40G EEE Proposal

Jim Graba

15 July 2014

Signal link partner (LP) to leave LPI mode - pt 1/2

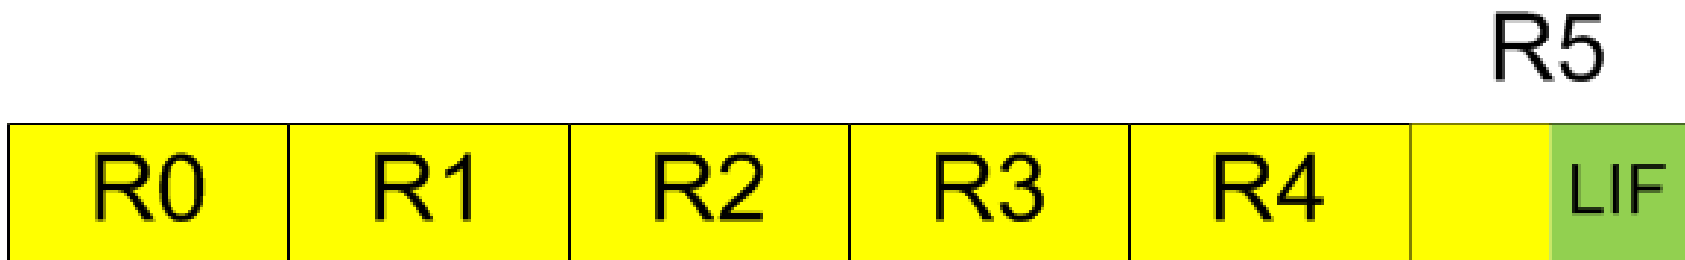
- A change in environment to an extreme operating point can stress the receiver during symmetrical LPI mode
- The receiver can recover if the LP transmitter transitions to Normal mode for a finite period
- The 10G EEE standard has no mechanism to tell the transmitter to leave LPI mode at the PHY level without involving higher layers
- Propose we use a back channel method to tell the LP transmitter to leave LPI mode temporarily
- The higher layers will be oblivious to this action

- Propose the last 128 symbols of Refresh be reserved for LPI back channel
- Use the same mechanism used to generate InfoFields as shown in Figure 55–13
- The back channel data should be general purpose allowing other information to be sent
- Disable LPI time should be in units of minutes
- Disable LPI time limited to 20 minutes in length
